Title: **QUALITY AUDIT (Stage 1&2)  
INCLUDING ROAD SAFETY AUDIT  
For;  
Glenageary Gate LRD**

Client: **AECOM**

Report reference: **1130R02**

This report was prepared in response to a request from Mr. Marc O'Dowd, AECOM, for a Stage 1&2 Quality Audit of a proposed large residential development (LRD) at Glenageary Co. Dublin.

Drawing 60690914-ACM-00-00-DR-CE-10-0001 Rev 1, Glenageary Avenue ped/cyclist crossing.

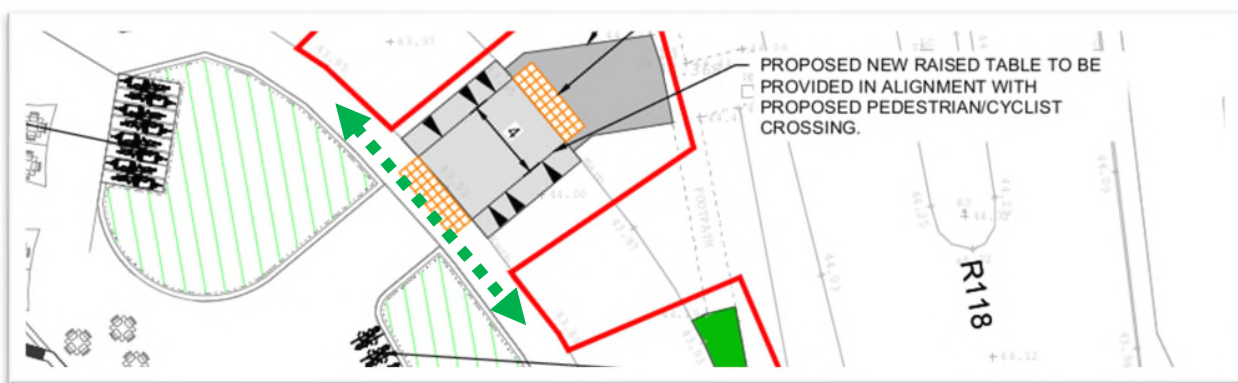
It is proposed to provide a 4m wide pedestrian/cyclists crossing of Glenageary Avenue. The facility joins with the pedestrian footpath only on the western side of Glenageary Avenue. Pedestrians on this footpath may not anticipate cyclists sharing this space, especially if they are blind or partially sighted. This could lead to collisions between pedestrians and cyclists.

It is recommended that warning tactile paving (ladder) and signage be provided in advance of the shared use crossing.

3.1	Yes	Yes	N.A.	
3.2	Yes	Yes	N.A.	
3.3	Yes	Yes	There will be a 1.3m wide new footway provided at the rear of the existing car parking spaces, to facilitate the desire line from the existing zebra crossing to the proposed development.	Yes

Drawing 60690914-ACM-00-00-DR-CE-10-0001 Rev 1, Glenageary Avenue, Disabled Parking Space.

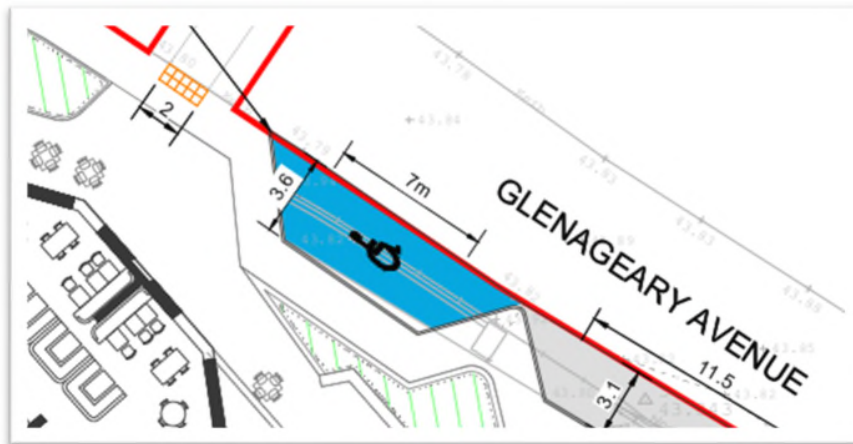
It is proposed to provide a disabled parking space on Glenageary Avenue. It is unclear if a dropped kerb is to be provided to allow users of this space gain entry to the footpath without having to travel along the carriageway to the nearby uncontrolled crossing.

It is recommended that a dropped kerb be provided to facilitate access to the footpath within the parking space.

Drawing 60690914-ACM-00-00-DR-CE-10-0001 Rev 1, Lidl.

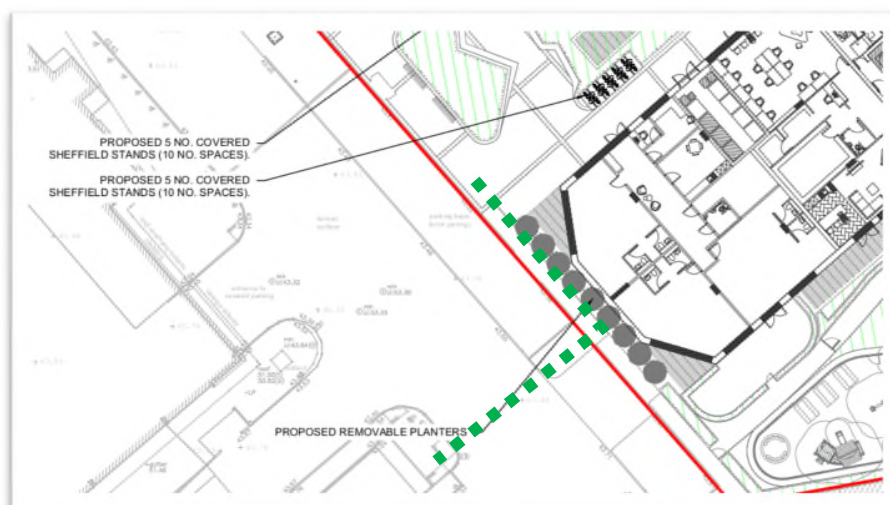
There will be a pedestrian desire line from the proposed Development to Lidl. It is unclear if this desire line is being accommodated with a path for pedestrians.

It is recommended that the desire line be accommodated with a clear route for pedestrians without steps or trip hazards.

Drawing 60690914-ACM-00-00-DR-CE-10-0001 Rev 1, Glenageary Avenue, uncontrolled pedestrian crossing.

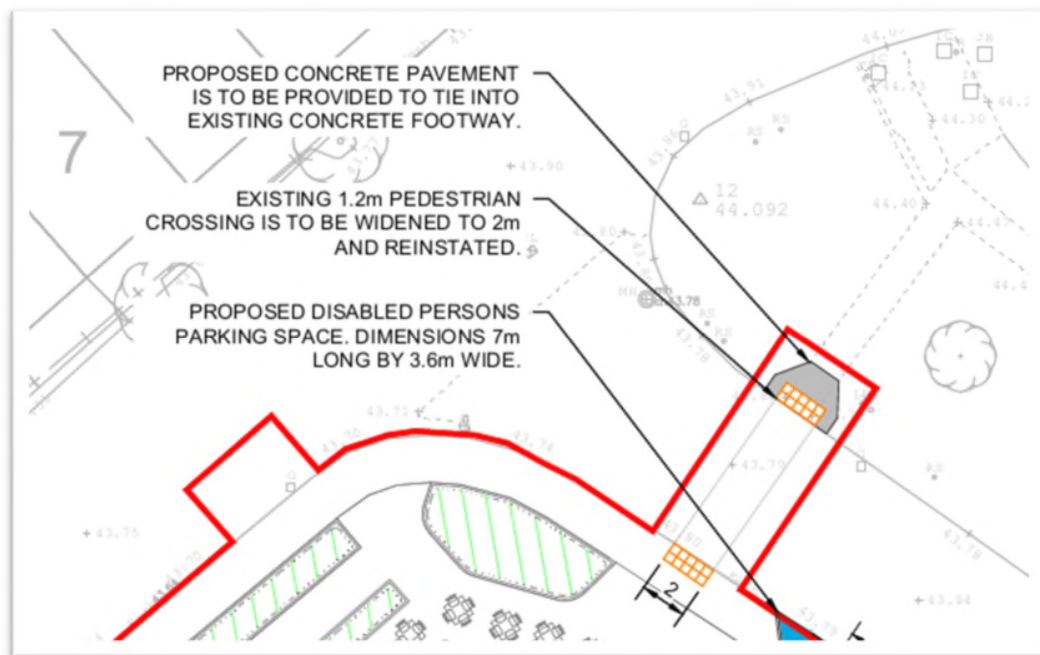
It is proposed to provide an uncontrolled pedestrian crossing on Glenageary Avenue. The start of the crossing on the island side towards Glenageary Roundabout forms an in-line crossing. The tactile paving of two slabs deep may not be enough to be adequately detected by some blind or partially sighted pedestrians which could result in those vulnerable road users stepping into the carriageway leading to possible collisions.

It is recommended that suitable depth tactile paving be provided at the in-line crossing.

3.4	Yes	Yes	As suggested, the tactile paving has been increased from 800mm (2 No. tactiles) deep to 1.2m (3 No. tactiles) deep.	Yes
3.5	Yes	Yes	New double yellow lines have been proposed on the nearside road carriageway from the proposed basement entrance to the existing An Post site entrance.	Yes

Drawing 60690914-ACM-00-00-DR-CE-10-0001 Rev 1, Basement access, Stop Sign.

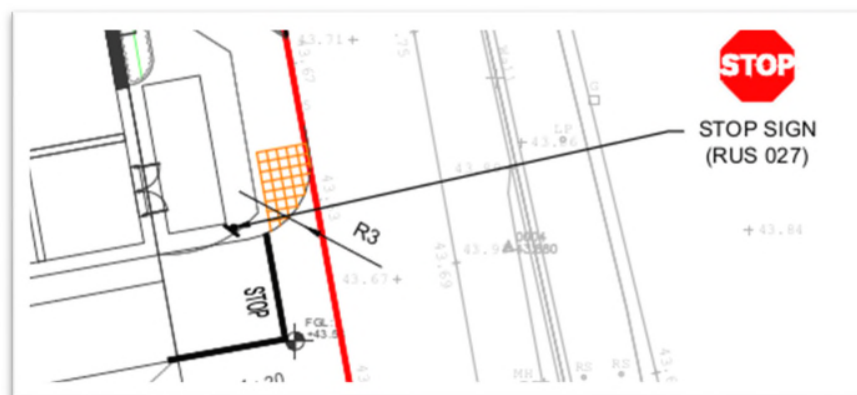
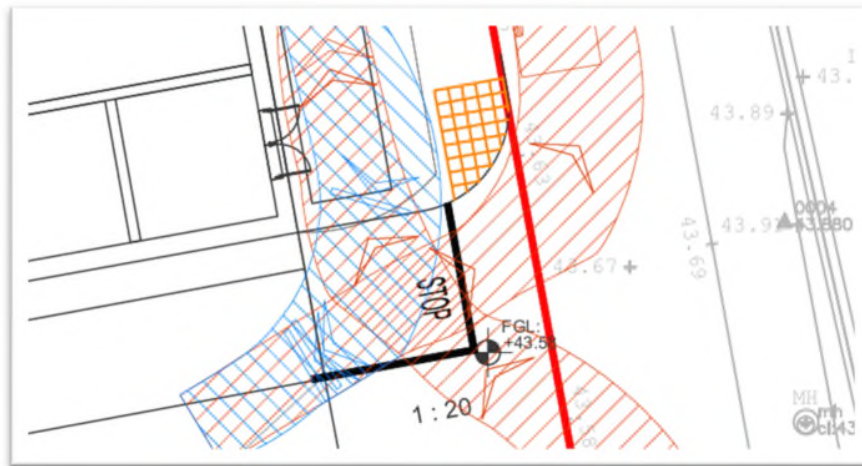
The stop sign at the top of the basement ramp will be in the swept path for the ESB maintenance vehicle. This could lead to damage of the sign pole and drivers subsequently not being warned of the need to stop.

Relocate the stop sign to a suitable position where it will not be a hazard for pedestrians.

3.6	Yes	Yes	N.A.	
3.7	No	Yes	The proposed rear garden will only be accessible by residents and not the public.  The proposed residential bin pick-up/drop-off point is only expected to be used as short-term bin storage during bin collection times. During all other times, the bins will be stored in the respective long term bin stores located within the basement.	Yes

Drawing 60690914-ACM-00-00-DR-CE-10-0001 Rev 1, Set Down Parking Sallynoggin Road.

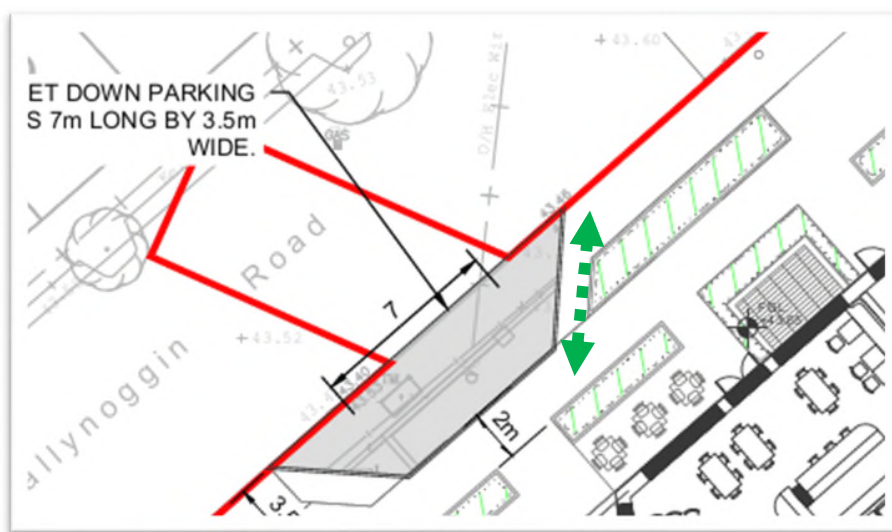
A set down parking space is proposed on Sallynoggin Road. The footpath at the rear of the parking space taper is relatively narrow and may not be sufficient for pedestrians to pass. Blind or partially sighted pedestrians may use the kerb edge to negotiate along Sallynoggin Road and not the area to the rear of the landscaped areas.

Ensure sufficient footpath space is provided.

3.8	Yes	Yes	A minimum of 2m clear footpath will be provided at all sides of the proposed set-down parking bay.	Yes

Drawing 60690914-ACM-00-00-DR-CE-10-0002 Rev 1, Basement.

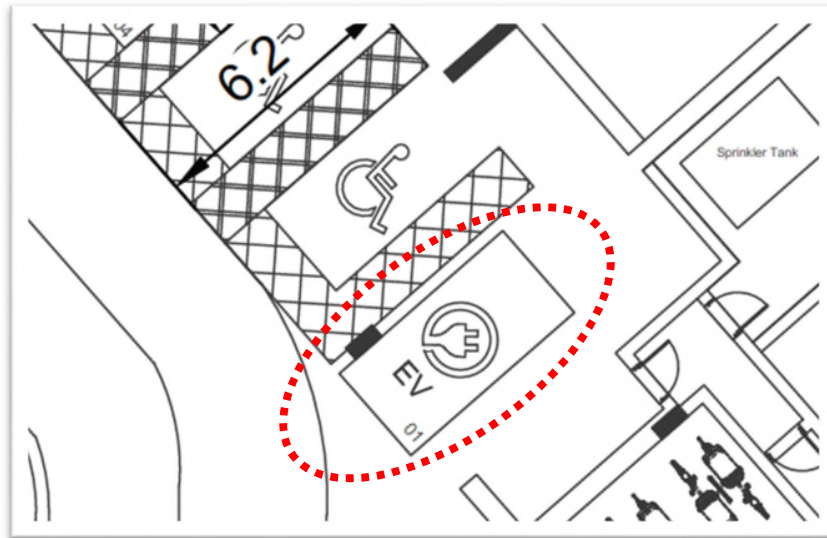
It is unclear where the charging unit will be located for the single EV charging space adjacent to the sprinkler tank. Loose cables could lead to trips and falls if on the path of pedestrians.

It is recommended that the column be protected and/or highlighted or relocated.

3.9	Yes	Yes	Column to be highlighted	
3.10	Yes	Yes	EV charger will be positioned, where possible, in a location where cables will not impede pedestrian movements.	Yes
3.11	Yes	Yes	This will be reviewed, and sufficient space will be provided for cargo bikes to enter/exit.	Yes

Drawing 60690914-ACM-00-00-DR-CE-10-0002 Rev 1, Basement.

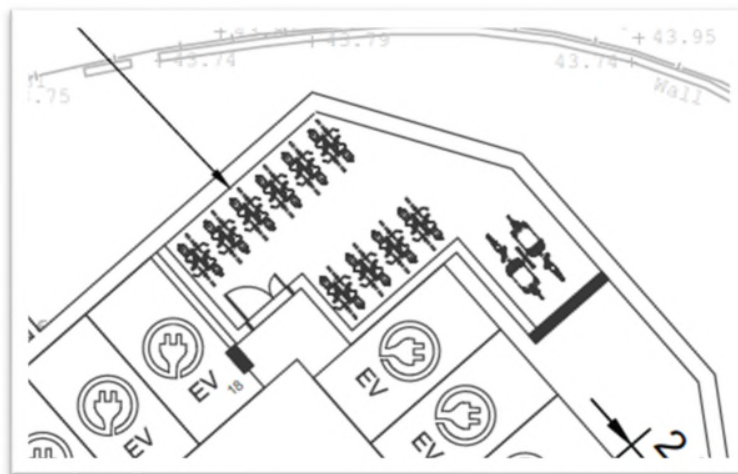
It is unclear if the long stay cargo bikes can get out of the bike store if other spaces are occupied and the doors are opened.

Ensure sufficient space is provided for the cargo bikes to get into and out of the storage area.
